DEVELOPMENT DETERMINATION PANEL MEETING

WEDNESDAY 11 APRIL 2018

ITEM 3.1 DA2017/1200 - 73 MARINE PARADE AVALON BEACH -
ALTERATIONS AND ADDITIONS TO A DWELLING HOUSE

ITEM 3.2 **N0316/17 - 2069 PITTWATER ROAD BAYVIEW - NEW
DWELLING AND POOL****REPORTING MANAGER** **Matthew Edmonds****TRIM FILE REF** **2018/213946****ATTACHMENTS** 1 [↓](#) **Assessment Report**
2 [↓](#) **Site and Elevation Plans****PURPOSE**

Figure 4: Extracts from information provided by the applicant from points above the eastern boundary denoting the locations of the proposed height breach.

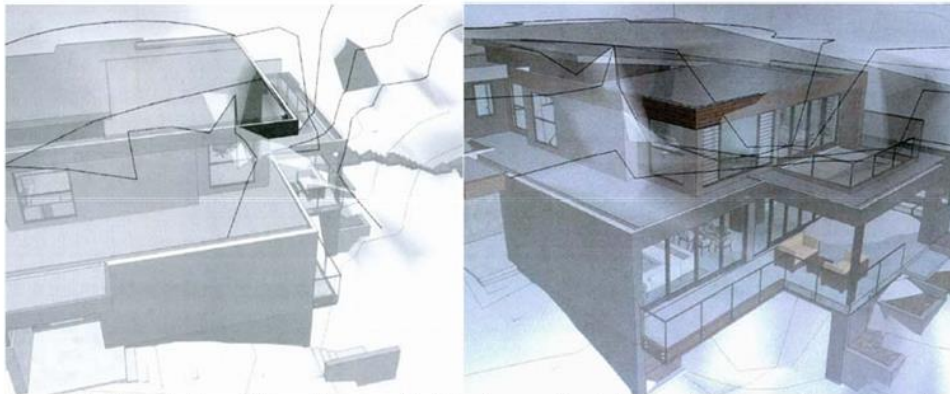
The largest breach is situated within the northeast corner of the first floor and is approximately 2.1m long x 3.7m wide (approximately 1.3m long x 2.8m wide excluding the eaves). The maximum height of the breach would be 1.3m, or a 15.3% variation to the 8.5m height standard. The areas of noncompliance would be below the maximum ridge height of the dwelling, which is situated further towards the rear of the proposed dwelling.

Despite the above, the same approach could not be applied to the height noncompliance above the car parking area, as that noncompliance would affect an external part of the building; unlike internal excavation, building bulk scale and visual impact can be considered with regard to existing ground levels. Further, earlier modifications to this part the site would affect the ability to accurately extrapolate natural ground levels.

Figure 1: North-western elevation drawing showing areas exceeding the 8.5m Height of Buildings development standard

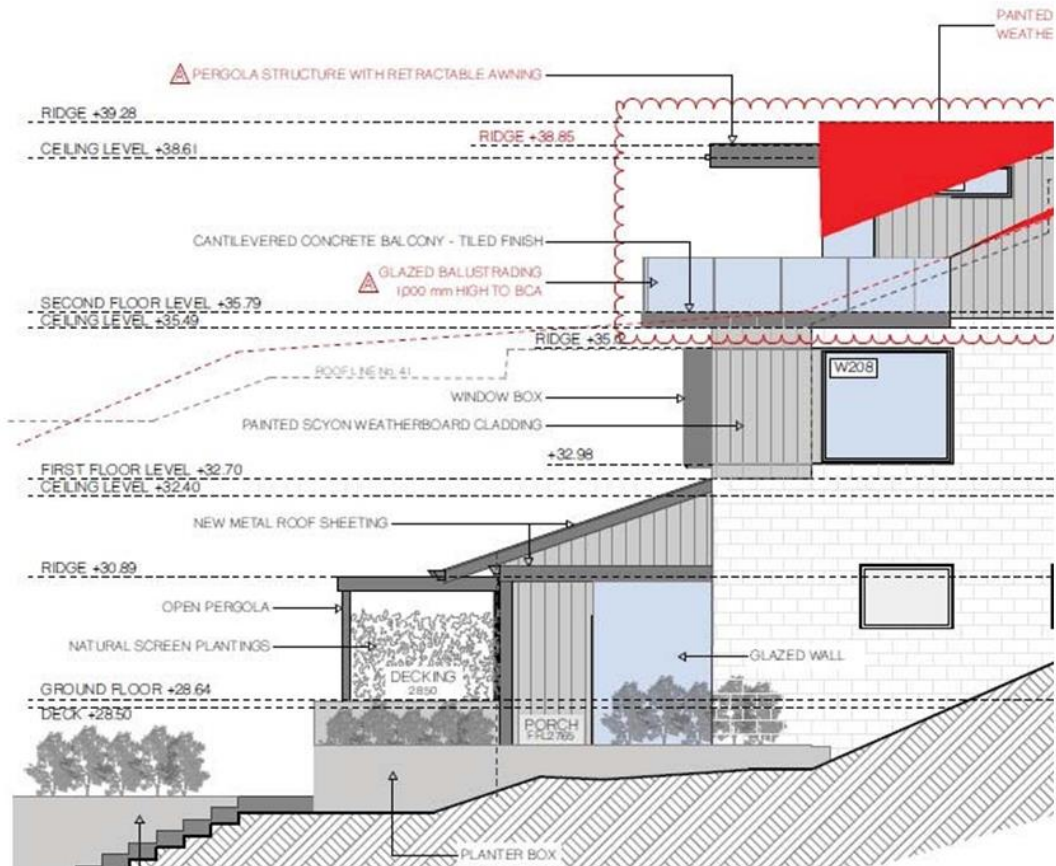
Requirement:	8.5m
Proposed:	Up to 11.554m (RL39.28)
Is the planning control in question a development standard?	Yes
Is the non-compliance with to the clause requirement a Numerical and / or Performance based variation?	Numerical
If numerical enter a % variation to requirement	35.8%
